# LAWRENCE LIVERMORE NATIONAL LABORATORY

SUBJECT: Memo report on Final Draft Report, "Reexamination of NUREG-0170 Spent Fuel Shipment Risk, Estimates"

**Comments on Final Draft Report**  
**Re-examination of NUREG-0170**  
**Spent Fuel Shipment Risk Estimates**

**LLNL Review Team**

Figure 1 Creep-Rupture Data for Stainless Steel and Zircaloy Tubing.

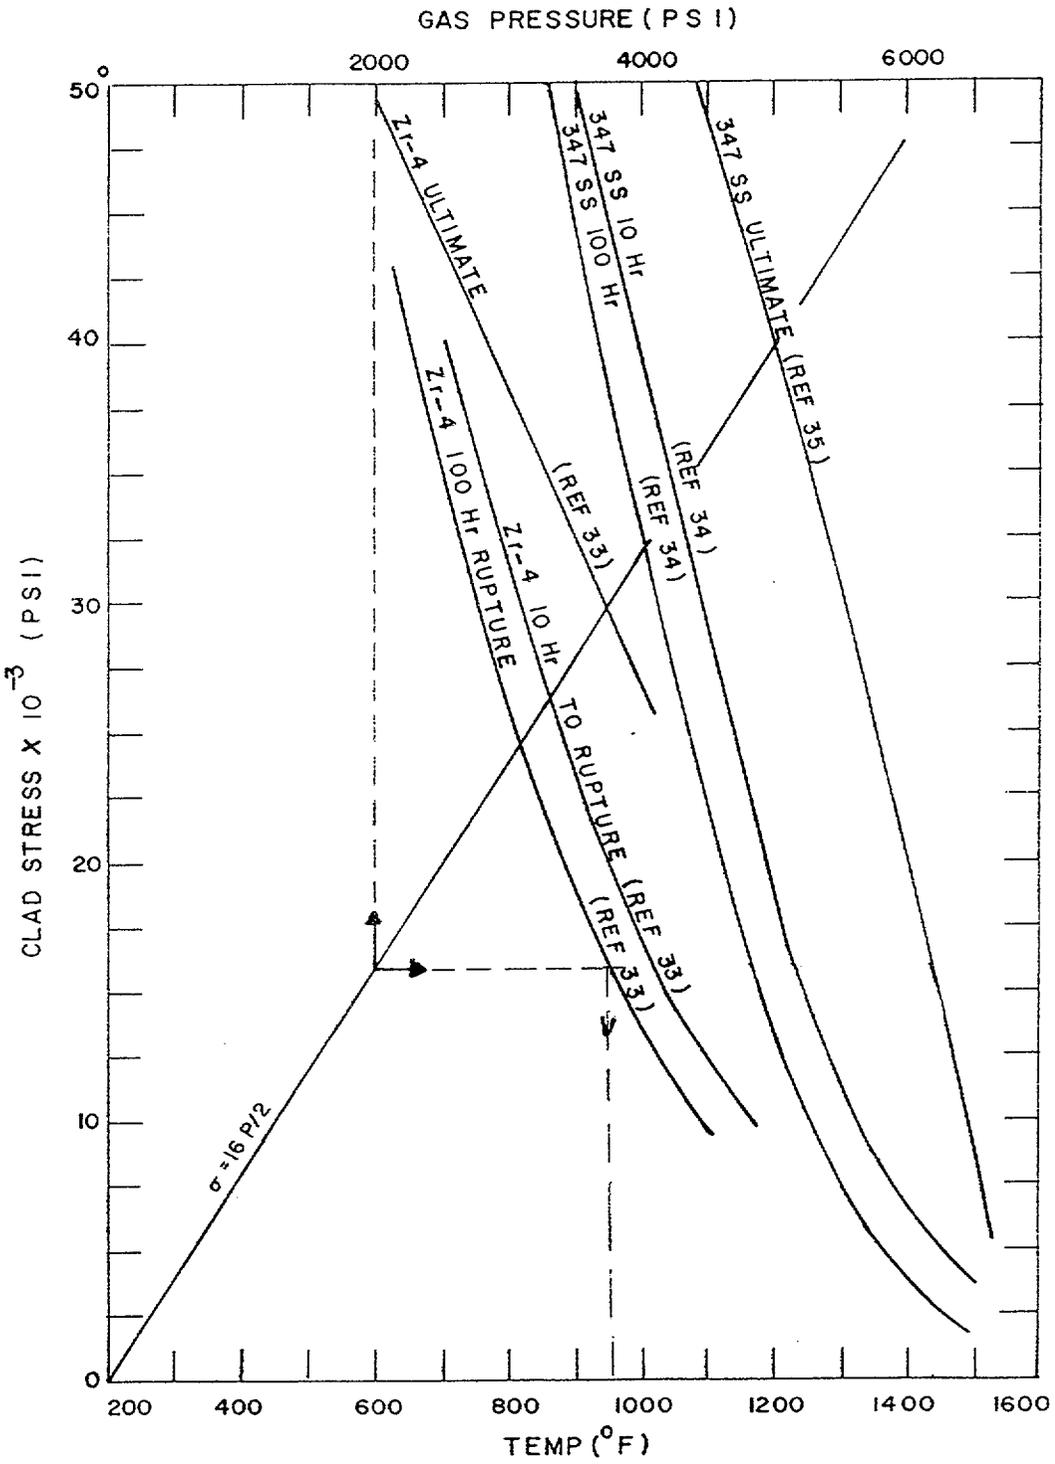
A brief analysis performed at LLNL using a 24 bundle rail cask (2.8 kW assembly) indicates that the 4 inner assemblies in a rail cask would likely undergo rod burst due to creep rupture within a few days following loading. The brief analysis is summarized in the following paragraphs.

The temperature of the fuel rods is estimated using the inner wall temperature of 215°C (Table 6.4). The temperature increase from the cask inner wall to the central four assemblies is estimated using reference 5 (p.136-140). The temperature increase to the four fuel assemblies with 852 watt average heat load for all assemblies in cask is  $210-90=120^{\circ}\text{C}$ . For an increased heat load from 852 W to 2796 W (Table 6.3) the temperature increase is  $120 \times 2796/852 = 393^{\circ}\text{C}$ . However, the higher temperatures for the hotter assemblies will increase the effective thermal conductivity by  $\sim 4/3$  resulting in an estimated temperature for the four center assemblies  $T = 393 (3/4) + 215 = 510^{\circ}\text{C}$  (950°F).

At the end of life the pressure in a fuel rod is near but below the PWR operating pressure of 2000 psi and is estimated to be 1600-1800 psi at 600°F. The rod

pressure at 950°F will be ~ 2000 psi. As shown in Figure 1, the rod will likely rupture after 100 hours of creep at 950°F <sup>16</sup>.

The SNL Study significantly underestimates the temperatures of the fuel rods, hence their time of failure, radioactive material releases, and the associated risks. As recommended at the July 29 meeting, the fuel burnup/cooling times should be specified such that the fuel assembly heat load is  $\leq 1$  kW so that the fuel rod temperatures are more realistic and the fuel failure rates are more reasonable.

Figure 2. Pressure vs. Log[Time]

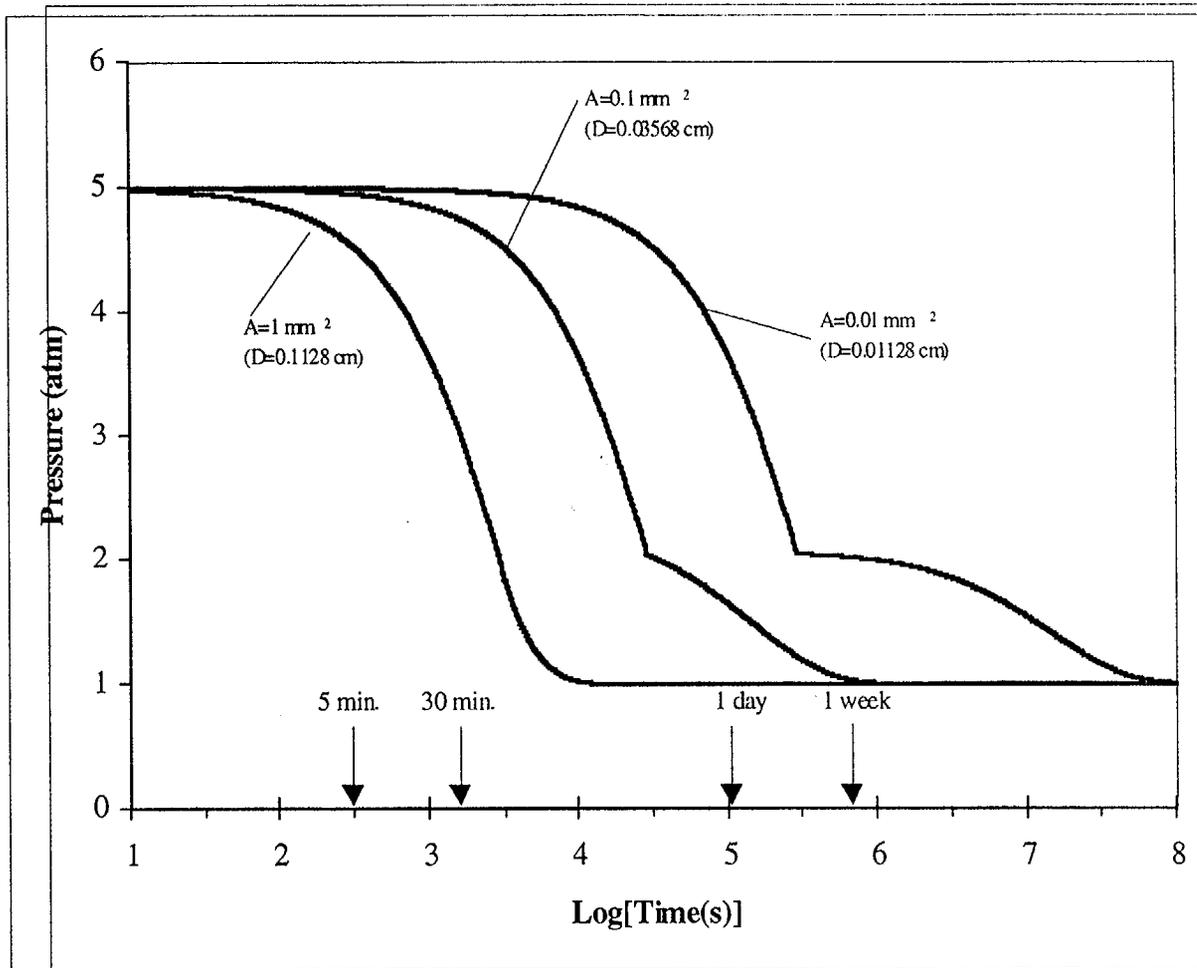
For a 1 mm<sup>2</sup> leak hole in a containment vessel initially at 5 atm with helium fill gas at an average temperature of 640° K, our analysis indicates that it takes about 30 minutes for the cask to depressurize to near ambient pressure. This result agrees with the MELCORE calculations given in the report for the time to depressurize a rail cask. The initial leakage rate for this depressurization is over 800 cc/s. For comparison, ANSI N14.5 considers a leak of 0.1 cc/s to be a large leak.

We also performed analyses on the time to depressurize a rail cask for leakage holes with cross-sectional areas of 0.1 mm<sup>2</sup> and 0.01 mm<sup>2</sup>. When the leak hole area is 0.1 mm<sup>2</sup> the cask takes less than 9 hours to depressurize, and when the

leak hole area is  $0.01 \text{ mm}^2$  the cask takes less than 4 days to depressurize. (See Figure 2.) The leakage rates for these two cases are  $80 \text{ cc/s}$  and  $8 \text{ cc/s}$ , respectively which are significantly higher than  $.1 \text{ cc/s}$ .

Figure 3. A<sub>2</sub>'s Released vs. Log[Time]

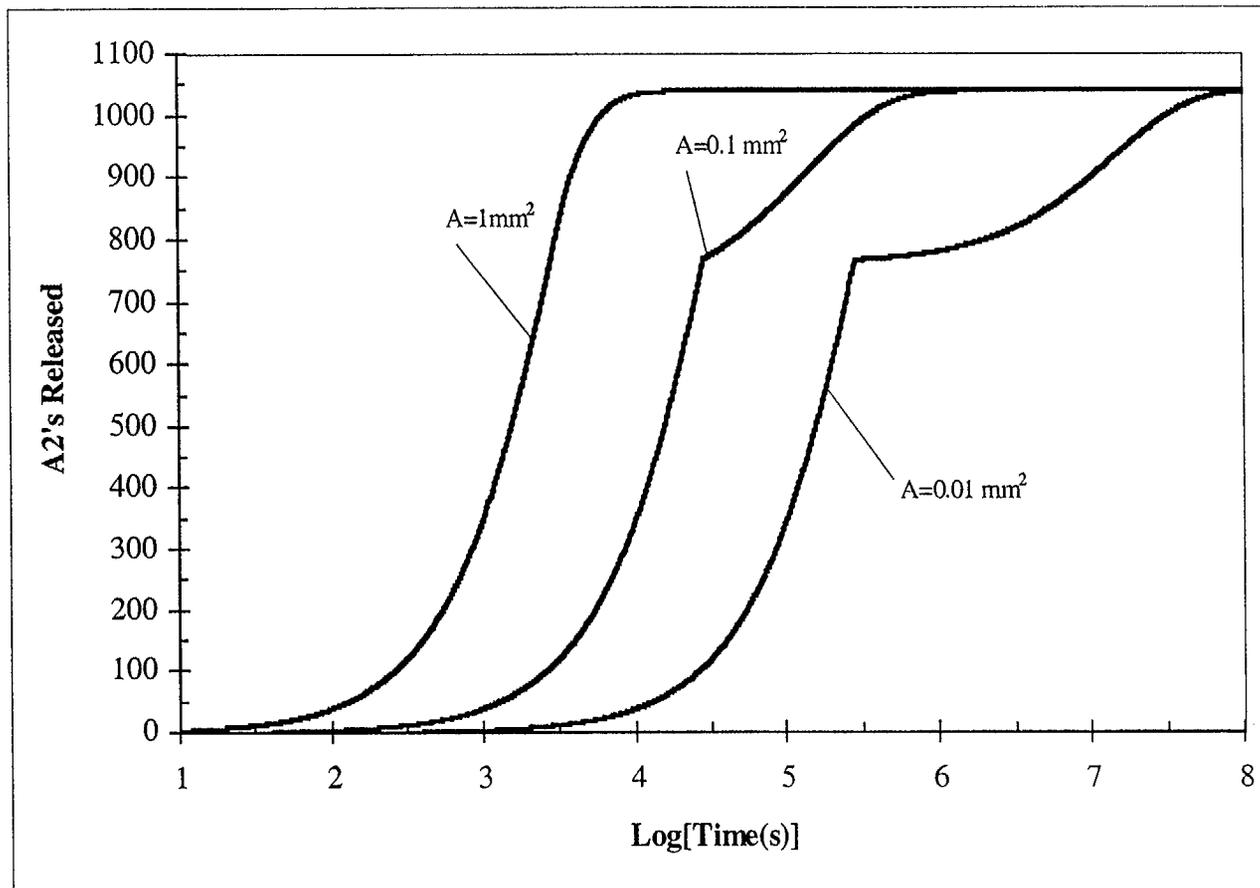
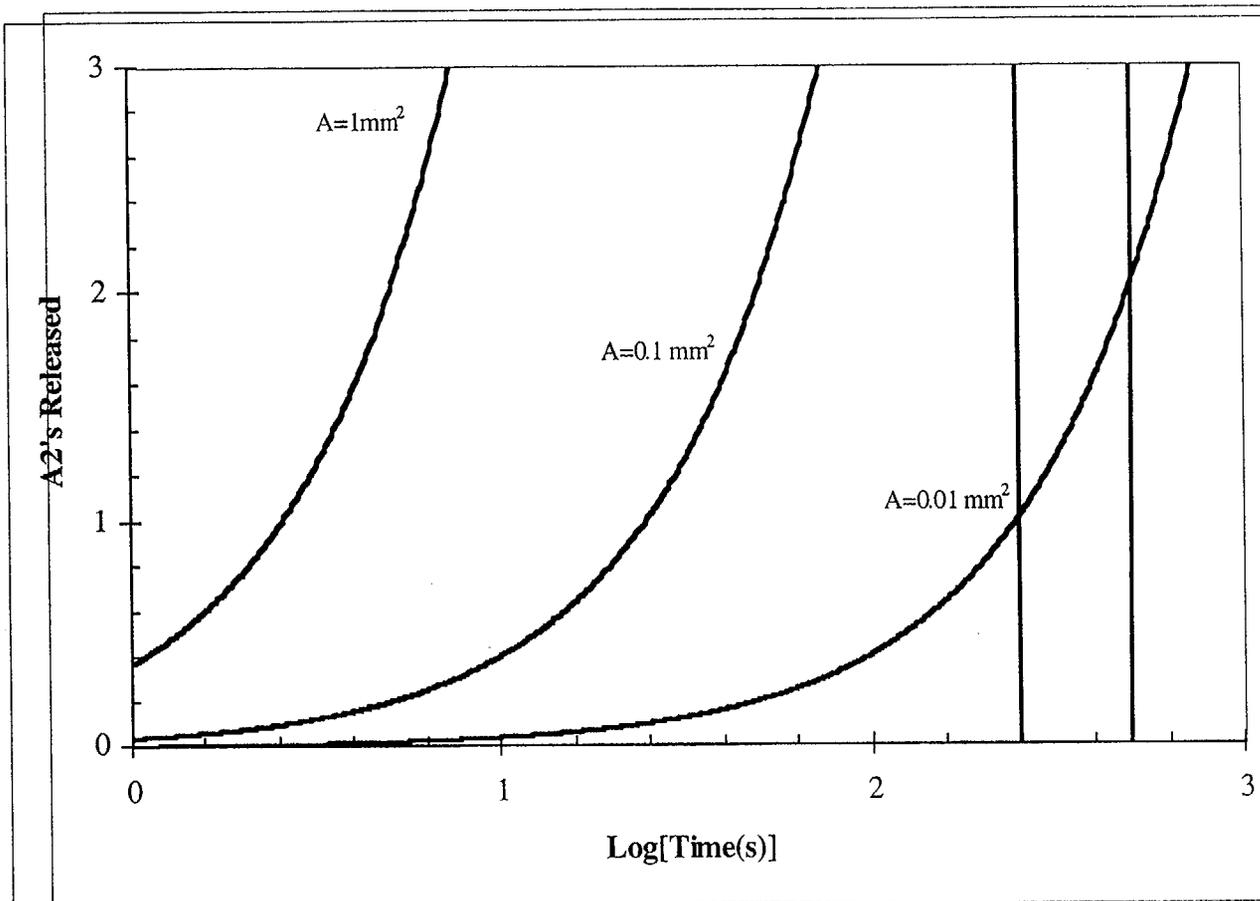
An analysis was performed to determine the number of  $A_2$ 's released from a rail cask holding 24 spent fuel assemblies for various leakage hole diameters. From NUREG/CR-6487<sup>[6]</sup>, the releasable source term for a rail cask holding 24 spent fuel PWR assemblies would have a total activity of 28,982 Ci. With an effective  $A_2$  for the releasable source term for PWR spent fuel under hypothetical accident conditions of 27.9 Ci, the releasable source term in the cask is equivalent to about 1040  $A_2$ 's. Using the following parameters, the number of  $A_2$ 's released, as a function of time for a rail cask is calculated for various leakage hole diameters:  $T=640 \text{ K}$ , Molecular weight of fill gas =  $4 \text{ g/gmol}$ , viscosity of fill gas =  $0.031 \text{ cP}$ , volume =  $2.68 \times 10^6 \text{ cc}$ , and leakage path length =  $10 \text{ cm}$ . The results for the number of  $A_2$ 's released as a function of time are shown in Figure 3. From Figure 3, it is clear that for the case when the leakage hole has an area of  $1 \text{ mm}^2$ , there are almost 400  $A_2$ 's released in less than 17 minutes. For hypothetical accident conditions, it is useful to determine the time that it takes to release one  $A_2$  of releasable material. Figure 4 shows the relevant region of Figure 3 to make this determination. From Figure 4, we see that the cask with a leak hole of  $1 \text{ mm}^2$  an  $A_2$  of materials is released in less than 10 seconds. For a cask with a leakage hole with an area of  $0.1 \text{ mm}^2$  it takes less than 100 seconds to release an  $A_2$ , and for the cask with a leakage hole with an area of  $0.01 \text{ mm}^2$  it takes less than 1000 seconds (17 minutes).

From these analyses it is clear that the hole sizes less than  $1 \text{ mm}$  should be evaluated for leakage flows and radioactive material releases or the radioactive material releases and associated risks will be significantly underestimated.
